# CREEKSIDE MEADOWS SECTION 4 CORRECTED PLAT

This Corrected Plat is being recorded to fix the ownership note for Lot 400 and Lot 449 on the existing plat of Creekside Meadows Section 4, recorded in Plat Book U, page 10. This recorded plat shows that Crestone Development, LLC owns a portion of Lot 400 and Lot 449; however, this ownership was conveyed to MOB, LLC in Document 2014R00028525.

## SHEET 1 OF 2

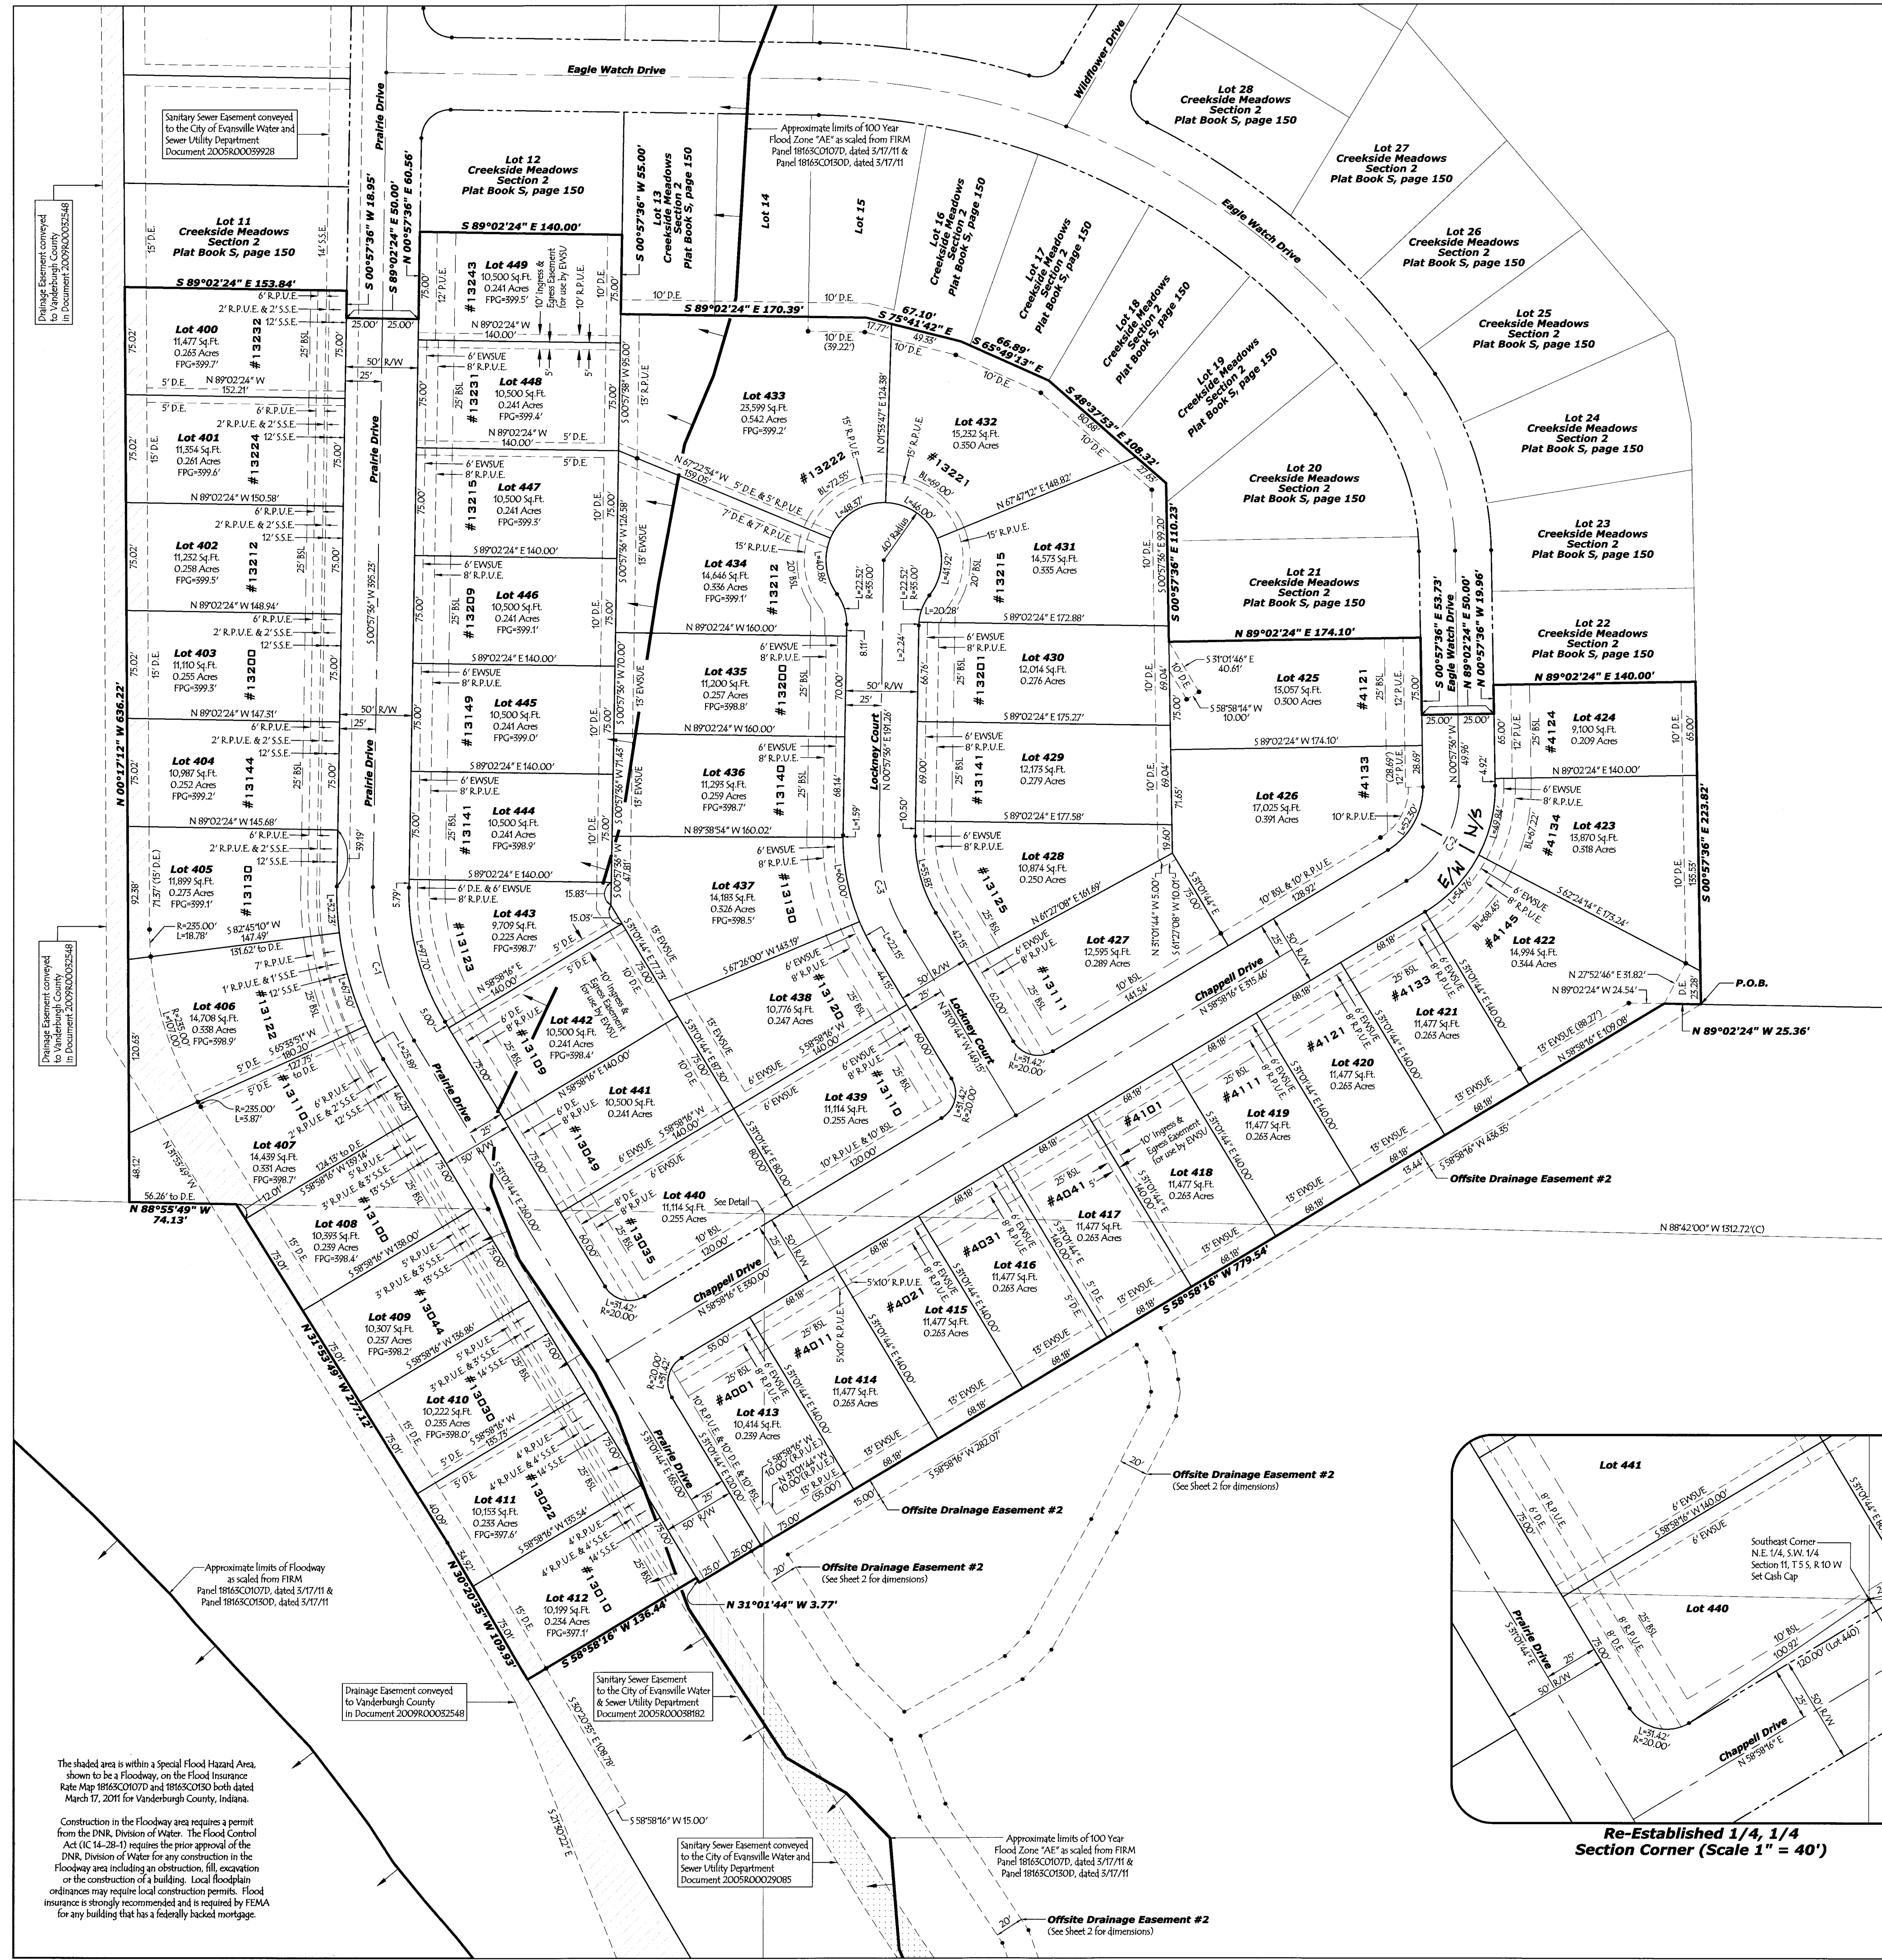
This Corrected plat removes the note that Crestone Development, LLC owns a part of Lot 440 and Lot 449 and it adds MOB, LLC as an additional owner of part of Lot 440 and 449 along with a Notary Certificate for MOB, LLC.
